REWIRING KIT 550002367 INSTRUCTIONS

FOR OIL FURNACE MODELS

W/30069 (OL2703) BECKETT AFII BURNER

REWIRING KIT INSTRUCTIONS

Figure 1 - Correct Wiring Diagram for HML80CB2U, HMLV80CB2U, BML80BB2U

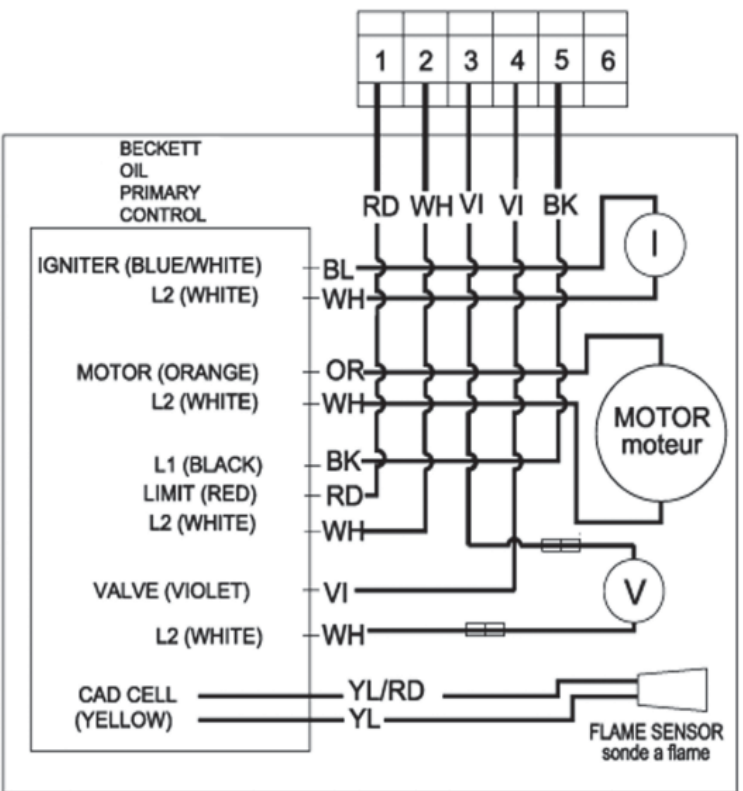
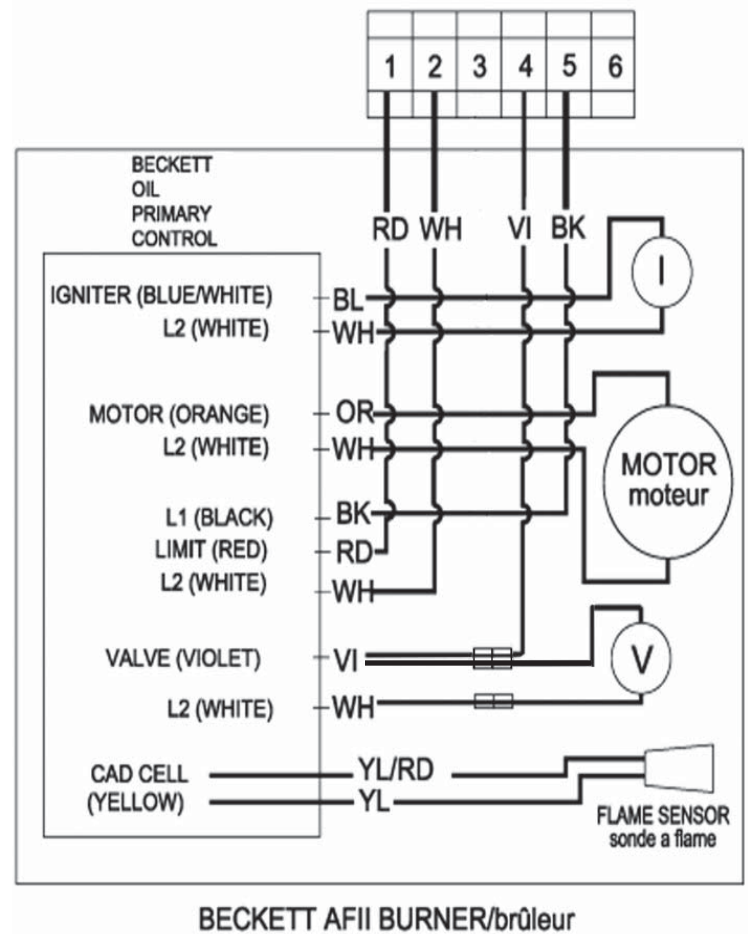
Incorrect wiring (see Figure 2):

If there are only four (4) wires in existing burner harness, and burner is wired as shown in **Figure 2**, existing four (4) wire burner harness needs to be removed and replaced with five (5) wire harness included with this kit.

1. Unplug four (4) wire burner harness from furnace harness at six pin moxex connector.
2. Disconnect four (4) wires in burner harness from their respective terminals on primary control.

3. Disconnect violet oil solenoid valve lead from violet two (2) wire jumper on VALVE terminal of oil primary.
4. Remove and discard violet two (2) wire jumper from VALVE terminal of oil primary.

5. Remove four (4) wire burner harness from oil burner and install five (5) wire harness in same manner using existing strain relief.
6. Connect the new five (5) wire burner harness per **Figure 1** as follows:

- A. Red wire to oil primary LIMIT terminal
 - B. White wire to oil primary L2 terminal
 - C. Black wire to oil primary L1 terminal
 - D. Violet wire with female connector to oil primary VALVE terminal

- E. Violet wire with male connector to violet oil solenoid valve lead.
 - F. Connect new five (5) wire burner harness to furnace harness by connecting six (6) pin moxex plug to six (6) pin moxex receptacle

10. Apply furnished wiring diagram label 240005212 REV B over existing wiring diagram label.
11. Resume operation using OPERATING INSTRUCTIONS found on Operating Instructions label on furnace or in Installation, Operation & Maintenance Manual.
